**HG1F-SB22YF-\***  
**(RS-485/RS422 Type)**

### Terminal Block Type (RS-485/RS-422 Comm. Port) of HG1F-SB22YF-\*

Some of the Terminal pin number layout on all table wiring diagrams in Host I/F Manual are incorrect.

**Figure1:** Shows correct Terminal type diagram.

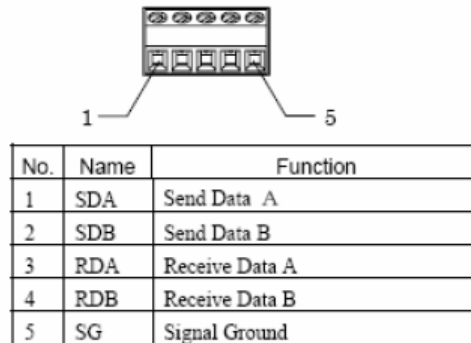
- \* Terminal SDB: Pin Number 3 is now replaced with Pin Number 2
- \* Terminal RDA: Pin Number 2 is now replaced with Pin Number 3

Note: When using the Terminal Block type of HG1F for communication, refer to Table1 (above) and make the necessary changes to the Pin Number on the table wiring diagram in Host I/F driver Manual.

**Example1: Wiring diagram 1-6 between Idec Microsmart (with FC4A-PC3/HPC3) and Terminal Type RS-485/RS-422 of HG1F.**

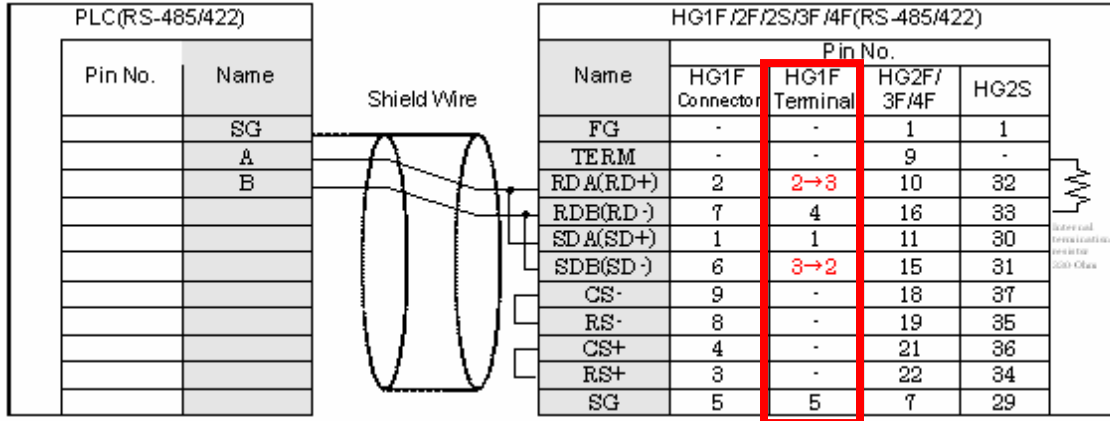
Under “HG1F Terminal” pin layout, the following pin numbers are corrected according to their labels (see Table 1 above as the reference).

2 → 3 : Pin #2 is now Pin #3

3 → 2 : Pin #3 is now Pin #2

Therefore, the correct wiring on the HG1F Terminal side as follows:

Pin#3 (RDA) and Pin#1(SDA) are connected.

Pin#4 (RDB) and Pin#2 (SDB) are connected.

**Correction on Wiring Diagram 1-6**

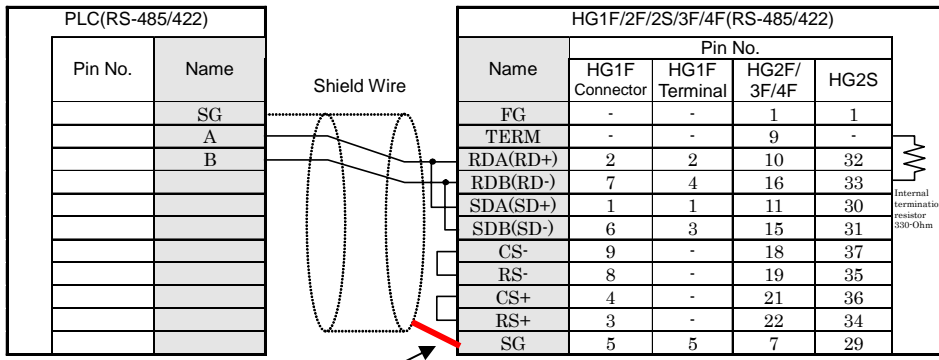
The wiring diagram 1-6 is lacking one connection.

The connection is between signal ground (SG) of MICRO/I and Shield Wire (refer to the RED line connection).

Wire added.

**Example 2:** During configuration of HG1F-SB22YF- \* in WindO/I- NV2, make sure the communication settings are as shown in the image below.

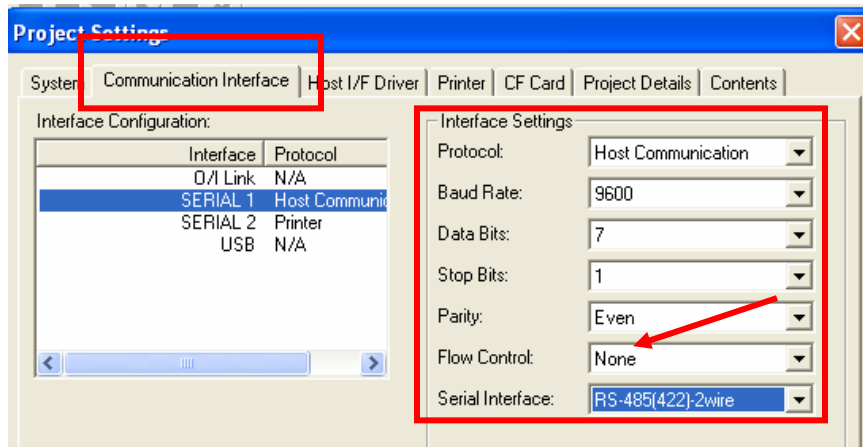
When you use the Terminal Block type of HG1F-SB22YF-\*, make sure to configure the **Hardware Flow control to NONE** because the HG1F doesn't have control lines.
